Access Compliance Report

Public Rights-of-Way

(Curb Ramps)

Intersection ID: 19716	Main Street: ASHLEY_FARM_DR	Cross Street: WYTHE_CT	Location:	N
ADA ID: 61F32E7995B0	Ramp Type: PerpDiag	Initial Pass/Fail: Fail	Overall Compliance: No	Severity Score: 37.5
Codes/Mitigation Info/Possible Solution		Field Measurements/Component Compliance

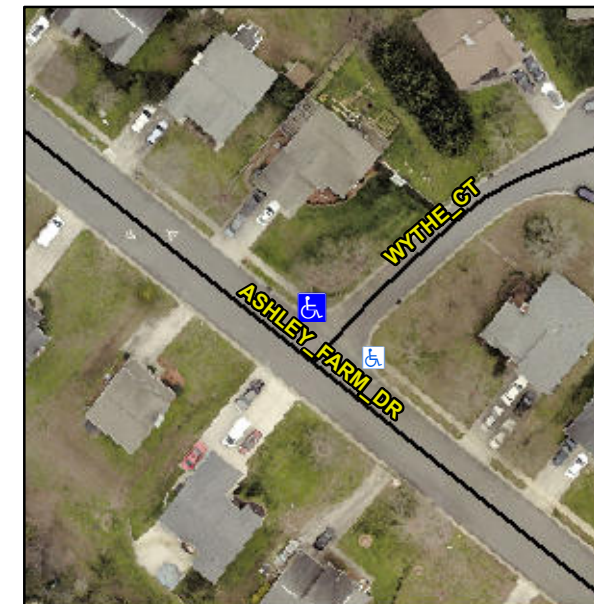
R304.2.2, R304.5.3

Compliance	Description	Data	Compliance	Description	Data
N/A	Ramp Length (in)	51.0	No	Ramp Slope (%)	12.4
Yes	Ramp Width (in)	48.0	No	Ramp XSlope (%)	6.5
N/A	Flare Type LT	N/A	N/A	Flare Type RT	N/A
N/A	Flare Slope LT (%)	N/A	N/A	Flare Slope RT (%)	N/A
N/A	Flare Traversable LT?	N/A	N/A	Flare Traversable RT?	N/A
N/A	Landing Length (in)	N/A	N/A	DWS Provided?	N/A
N/A	Landing Width (in)	N/A	N/A	DWS Contrast?	N/A
N/A	Landing Slope (%)	N/A	N/A	DWS Length (in)	N/A
N/A	Landing X Slope (%)	N/A	N/A	DWS Full Width?	N/A
N/A	Landing Curb? (Y/N)	N/A	N/A	DWS Offset (in)	N/A
N/A	Shared Landing?	N/A			
N/A	Gutter Ponding?	N/A	N/A	Gutter Slope (%)	N/A
N/A	Gutter Lip Ht (in)	N/A	N/A	Gutter X Slope (%)	N/A
N/A	Painted X Walk1?	No	N/A	Painted X Walk2?	No
	X Walk 1 Direction	To SW		X Walk 2 Direction	To SE
N/A	X Walk 1 Width (in)	N/A	N/A	X Walk 2 Width (in)	N/A
	X Walk 1 Slope (%)	3.9		X Walk 2 Slope (%)	3.5
	X Walk 1 X Slope (%)	4.5		X Walk 2 X Slope (%)	0.6

Remove & Replace Curb Ramp With Two New Directional Ramps or Equivalent.
